aiwa

SERVICE TECHNICAL INFORMATION

MODEL : TV-1402KE/2002KE/2102KE

SUBJECT : Part Number of EEP ROM (IC002/NVM3060)

Schematic diagram (Wiring diagrams are shown on the next page.)

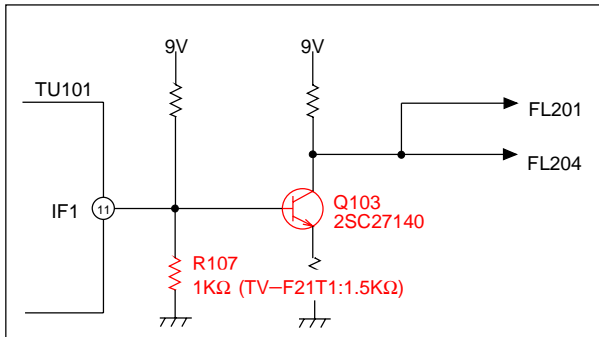
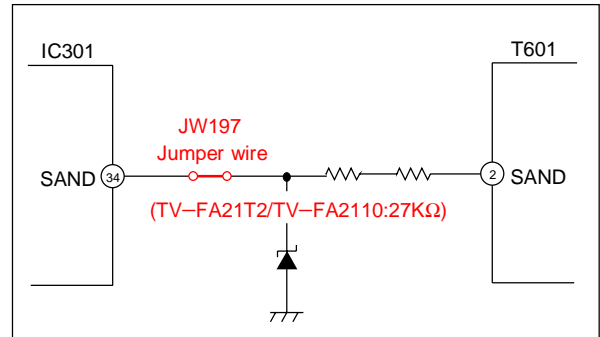
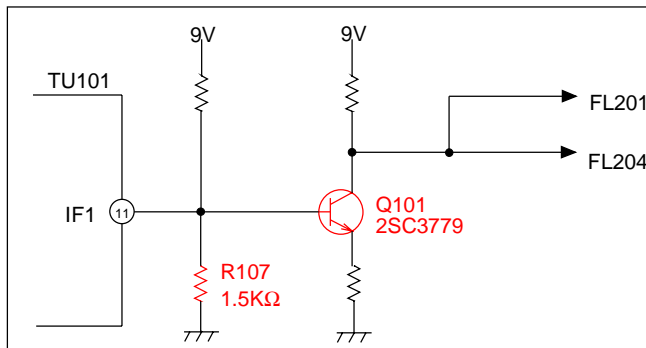
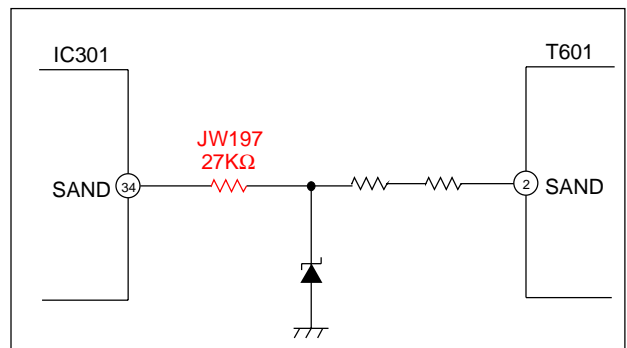
The peripheral circuit that is connected to Pin 34 of IC301 in TUNER block has been changed. Please confirm the circuit construction(Circuit or Circuit 2), and use the appropriate parts for each type of the circuit.

Modifications			
Ref No.	Circuit 1	Circuit 2	Affected Models
Q101	No mounting	TR,2SC3779	All models(On tuner block)
Q103	C-TR,2SC27140	No mounting	All models(On tuner block)
R107	C-RES,U 1K-1/16W	C-RES,U 1.5K-1/16W	TV-FA21T2 / FA2110 only (On tuner block)
JW197	Jumper wire	RES,27K-1/8W	TV-F21T1 only (On the line of IC301 Pin34)

Wiring diagram

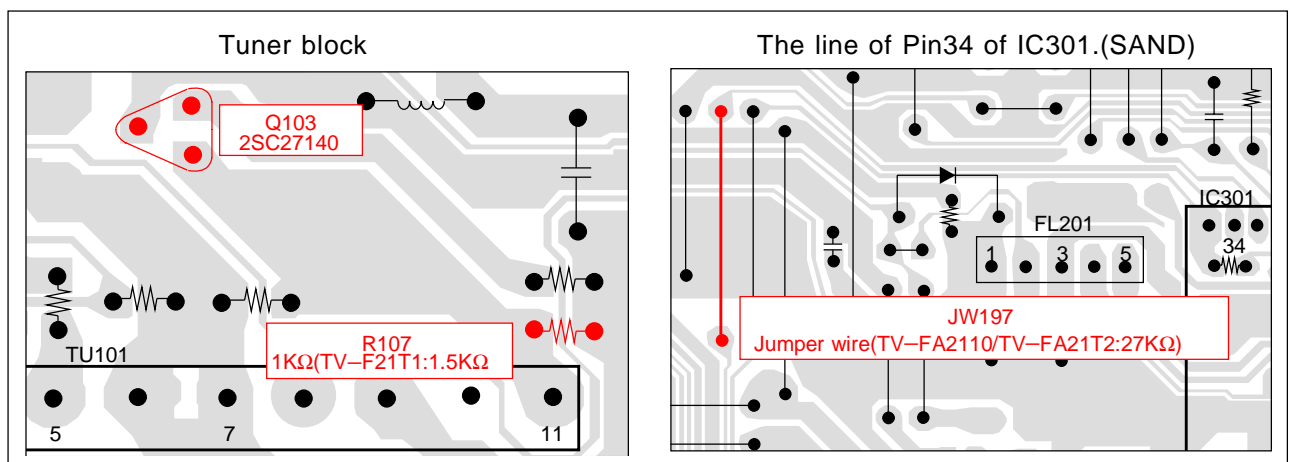
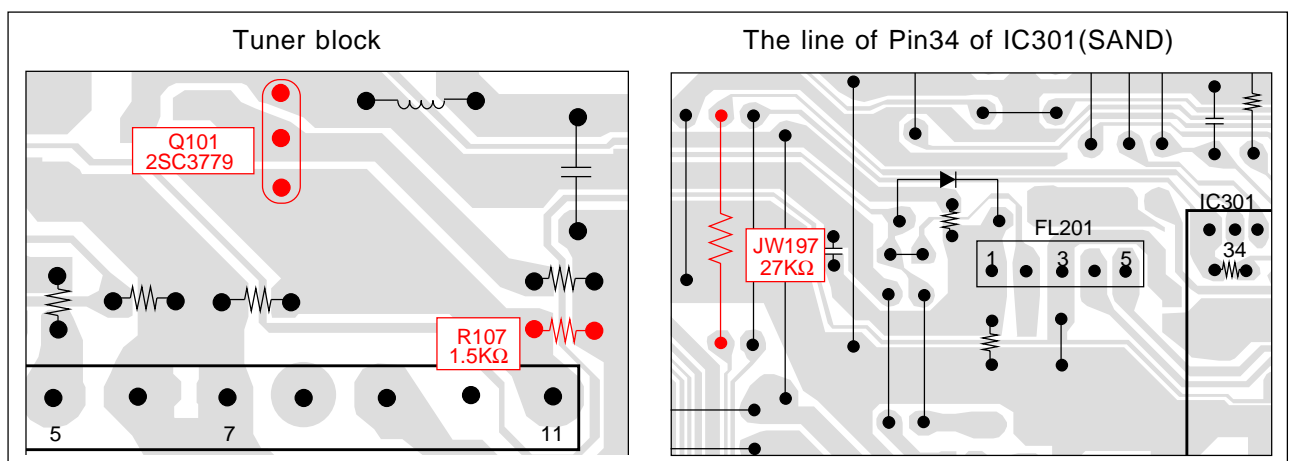
The improper use of spare parts will be cause of the beat noise on Aerial.

When the buzz noise arises on Aerial or line input of TV-F21T1(Circuit 1), mount the 27KΩ instead of JW197.

fig.1

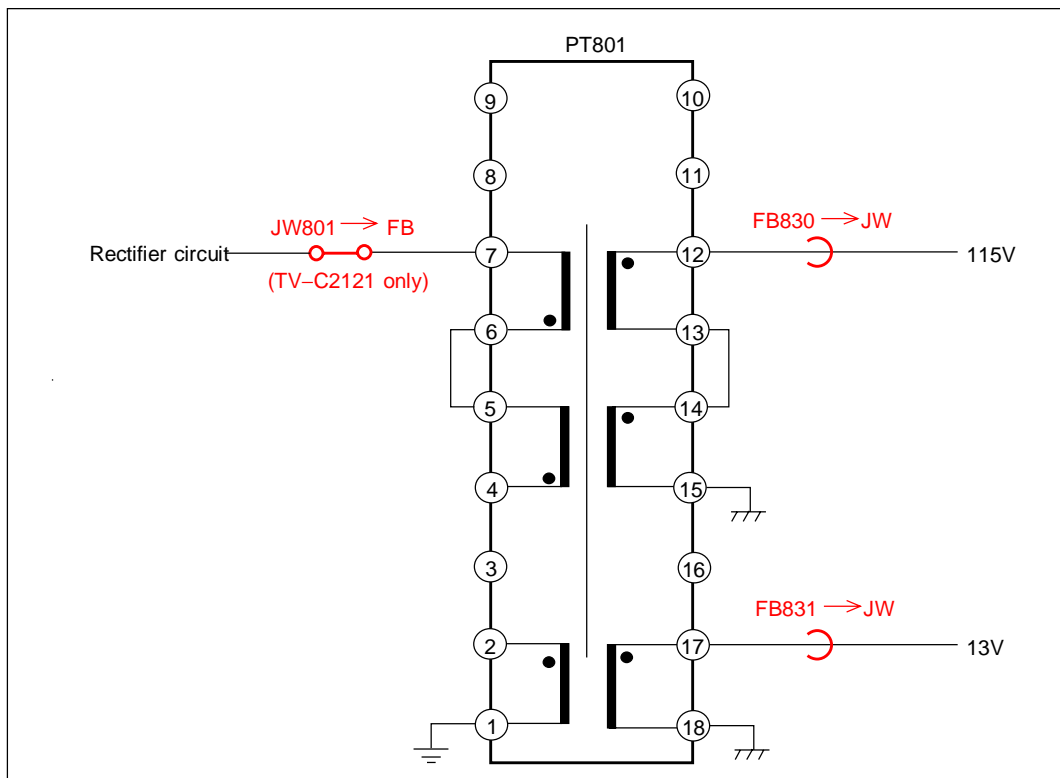
A beat noise problem may arise by influence of the power supply circuit.
Especially, this problem will happen in low electric field or VHF LOW channel.

1. Replace the FB830 and FB831 in the secondary stage of the power supply to the jumper wires. (see fig.2)
2. Remove the JW606 and JW608 which connect the GND traces.(see fig.3)
3. Replace the JW801 at the primary stage of the power circuit to the ferrite beading.(see fig.4)

fig.2

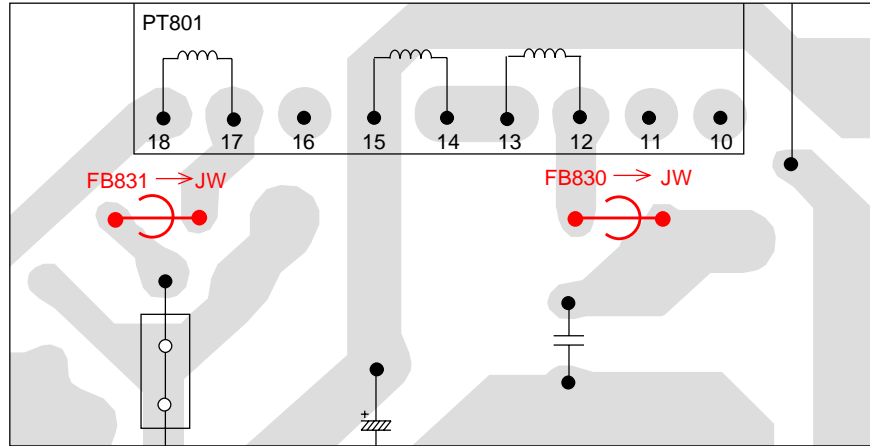
1. Replace the FB830 and FB831 of the secondary stage of the power supply to the jumper wire.

fig.3

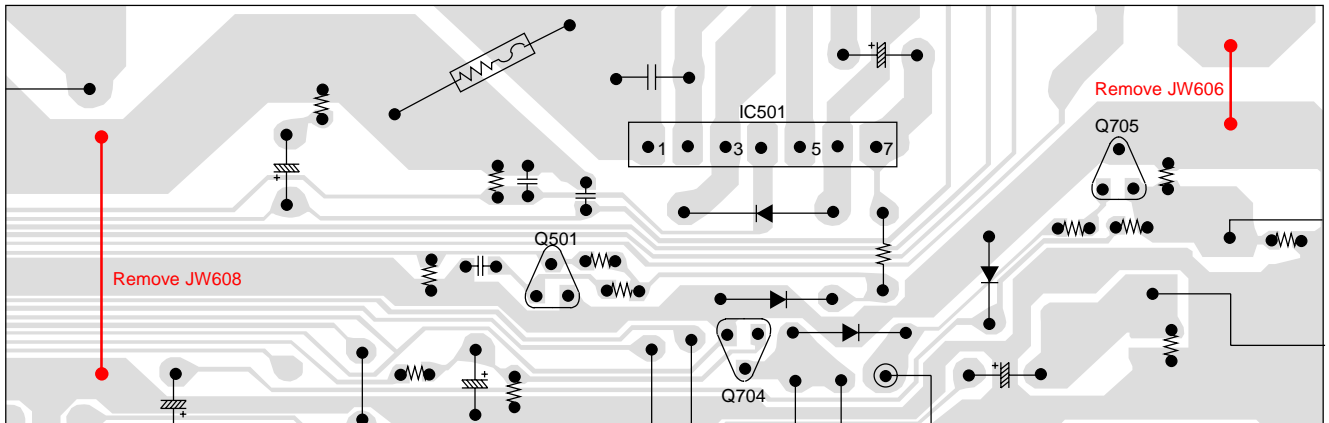
2. Remove the JW606 and JW608 which connect the GND traces.

fig.4

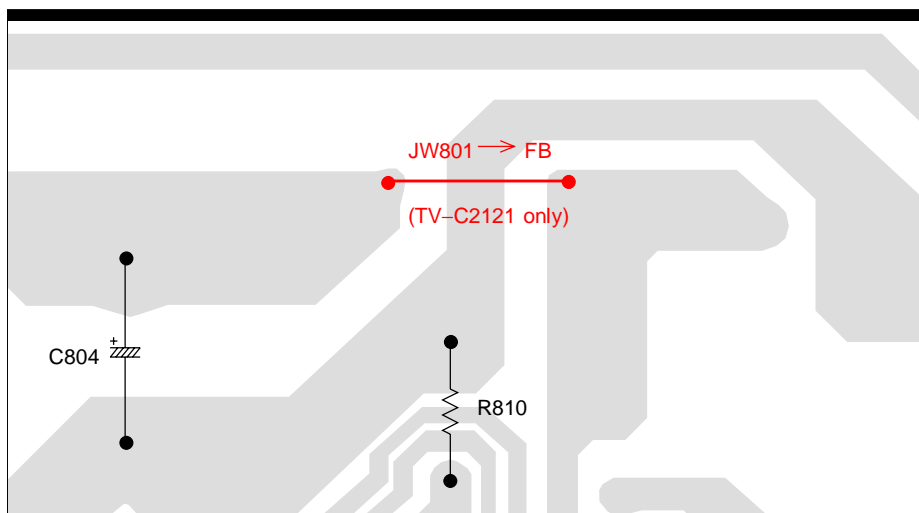
3. Replace the JW801 at the primary stage of the power circuit to the ferrite beading.

Ref.	Parts Code	Description	Remarks
JW801	87-003-320-080	F-BEAD,FBR07HA121NB	-

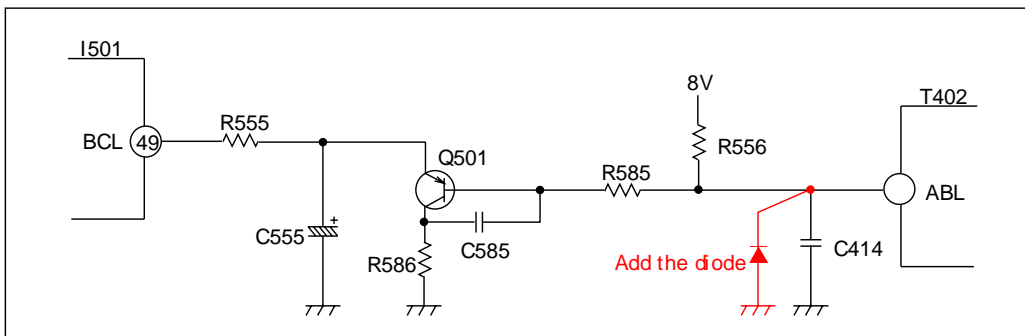
- 1) Replaced a CRT.
- 2) A failure of R556 was confirmed.

1. Add the diode between C414 and C305(GND) as the picture below.
2. Fix it with a glue.
3. Confirm a value of resistor, a color of R556, and replace it if found any defect.

Ref.	Parts Code	Description	Remarks
-	87-017-781-080	DIODE,1N4004	-

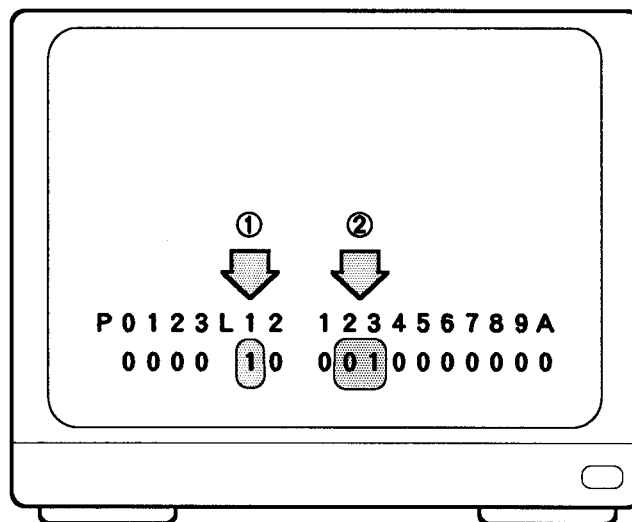
SUBJECT : Service manual of the model in question contains an error in service-mode setting values to be specified after replacing EEP ROM. Setting of erroneous value may lead to a failure in Portuguese OSD display.

- Correct the service manual setting of OSD display into values shown in the following figure.
- After a repair, set to the specified values .

The correct values for ① and ② of TV-A215RH must be set as shown in the figure. After repairing the EEP ROM ,set the values as shown in the figure.

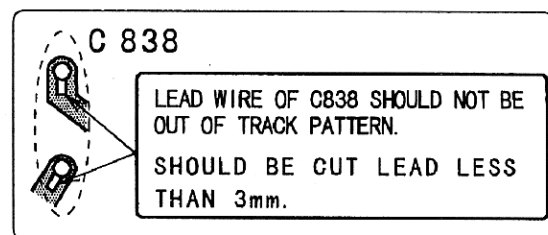
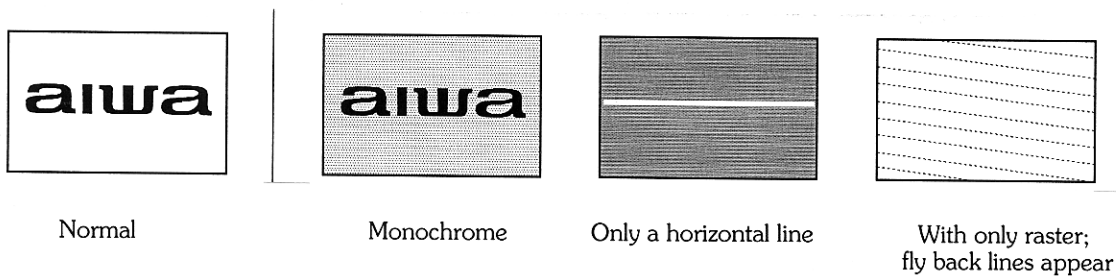
- Specified capacitor: C838
 1000P • 1K K → 1000P • 1K K R
- When the equipment does not operate due to a faulty peripheral part, exchange the following parts with new ones.
 IC801, F801
- During soldering, take great care to the following respects.

Ref.	Part Name	Part No.	Remarks
C838	CAP, CER 1000P-1K K R	87-A10-832-01/08	CHANGED FROM 87-016-515-080
IC801	IC, STR-S6707	87-A20-517-010	
F801	FUSE, 4A 250V T 218	87-035-458-010

Fig-1

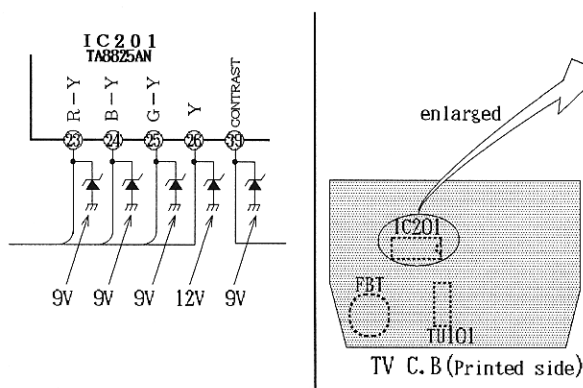
1. Connect 9.0 V ZENER DIODE (KIT, A TV-1452) between IC201's PIN23 and GND, PIN24 and GND, PIN25 and GND, PIN39 and GND (See Figures 1 & 2).
2. Connect 12 V ZENER DIODE (KIT, A TV-1452) between IC201's PIN26 and GND (See Figures 1 & 2).

Figure 3: TV C. B (Parts side)

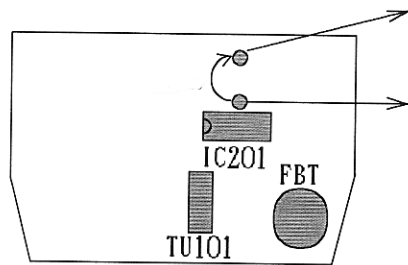
3. Move C206 to the position designated in Figure 3.

Removed capacitor must be mounted here.
"C206" is displayed. Make sure the polarity is correct.

Figure 4: CRT C. B (Printed side)

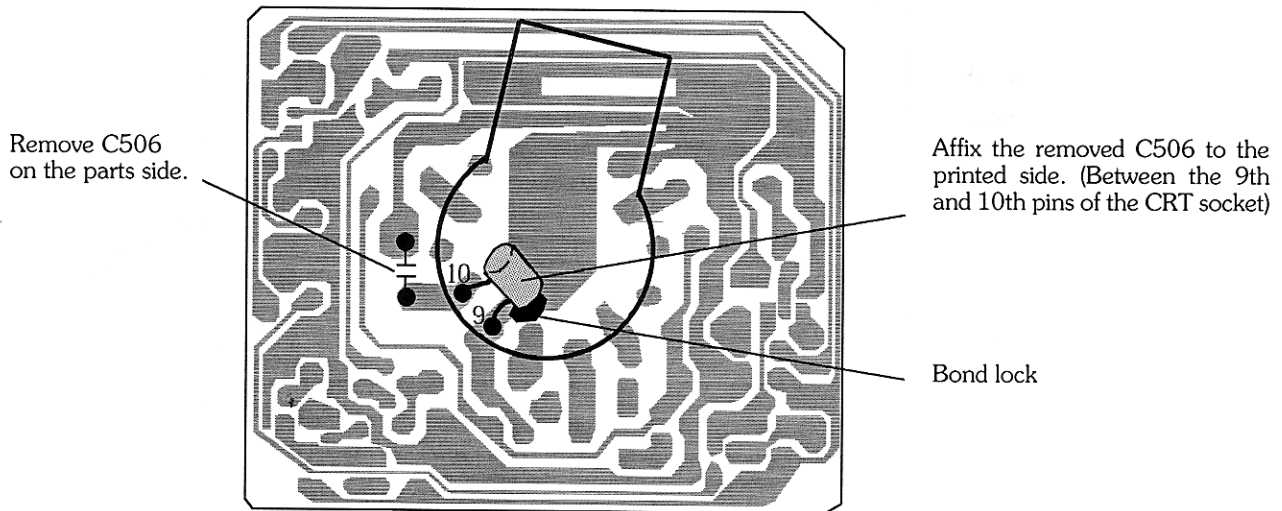
4. Remove C506 mounted on the parts side, and affix it to the printed side as shown in Figure 4.
